Access Compliance Report

Public Rights-of-Way

Intersection ID: 11541	Main Street: W_9TH_ST	Cross Street: N_PINE_ST	Location: S
ADA ID: DB470D4EDF94	Ramp Type: PerpDiag	Initial Pass/Fail: Fail	Overall Compliance: No
Severity Score: 46.25			
Codes/Mitigation Info/Possible Solution		Field Measurements/Component Compliance

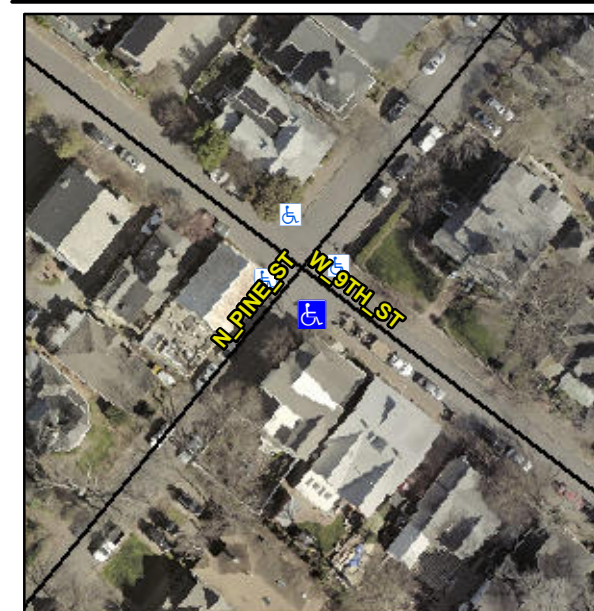
Not Found, R304.5.1, R304.2.2, R304.5.3

Compliance	Description	Data	Compliance	Description	Data
N/A	Ramp Length (in)	39.0	No	Ramp Slope (%)	10.2
No	Ramp Width (in)	43.0	No	Ramp XSlope (%)	11.2
N/A	Flare Type LT	N/A	N/A	Flare Type RT	N/A
N/A	Flare Slope LT (%)	N/A	N/A	Flare Slope RT (%)	N/A
N/A	Flare Traversable LT?	N/A	N/A	Flare Traversable RT?	N/A
N/A	Landing Length (in)	N/A	N/A	DWS Provided?	N/A
N/A	Landing Width (in)	N/A	N/A	DWS Contrast?	N/A
N/A	Landing Slope (%)	N/A	N/A	DWS Length (in)	N/A
N/A	Landing X Slope (%)	N/A	N/A	DWS Full Width?	N/A
N/A	Landing Curb? (Y/N)	N/A	N/A	DWS Offset (in)	N/A
N/A	Shared Landing?	N/A			
N/A	Gutter Ponding?	N/A	N/A	Gutter Slope (%)	N/A
N/A	Gutter Lip Ht (in)	N/A	N/A	Gutter X Slope (%)	N/A
N/A	Painted X Walk1?	No	N/A	Painted X Walk2?	No
	X Walk 1 Direction	To NE		X Walk 2 Direction	To NW
N/A	X Walk 1 Width (in)	N/A	N/A	X Walk 2 Width (in)	N/A
	X Walk 1 Slope (%)	6.4		X Walk 2 Slope (%)	2.2
	X Walk 1 X Slope (%)	1.3		X Walk 2 X Slope (%)	3.8

Remove & Replace Curb Ramp With Two New Directional Ramps or Equivalent.
